FOUNDATION INVESTIGATION REPORT

Hwy. 403 W.B. Over Hwy. 401 E.B.
Bridge #27
W.P. 127-66-10, Site #24-318
District #6, Toronto

FOUNDATION INVESTIGATION REPORT
For
Bridge No. 27
The Proposed Hwy. 403 Ramp E-S Overpass
Over Hwy. 401 E.B. Collector & Sub-Collector
Town of Mississauga, County of Peel
District #6 (Toronto, Ont.)
W.O. 73-11038 -- W.P. 127-66-10X

Ramp E-S over Hwy. 401
Bridge #27
W.P. 127-66-10, Site 24-318
District 6, Toronto

DIST 6	CONT No WP No 127-66-10	SHEET
405 WS OVER 401 EB. 80.065 27 FOOTING 3

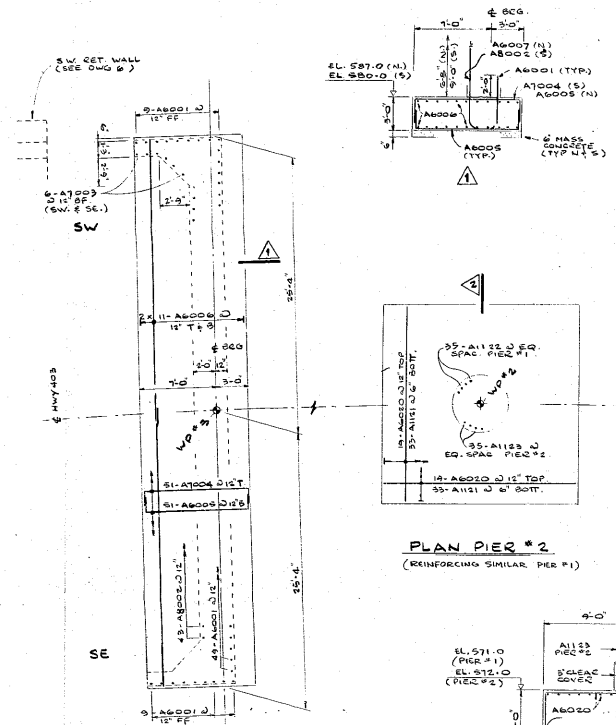
We present the following comments on the Preliminary Bridge Plan Drawing No. 24-318-P2 for the above mentioned structure:

1. The founding level of the footing for the south abutment is shown to be at about elevation 575.5. We believe that the footing could be placed on sound shale bedrock at elevation 583.0 (Refer B.H.'s 5 & 6).
2. The base of the footing for the north abutment is located at about elevation 588.0. At this level, weathered shale bedrock is present. We recommend that the base of the footing be founded within sound bedrock at about elevation 580.0 (Ref. B.H.'s 1 & 2).
3. The approximate bedrock surface in the vicinity of the south abutment as shown on Dwg. 24-318-P2 does not comply with our Drawing 73-11038 A.
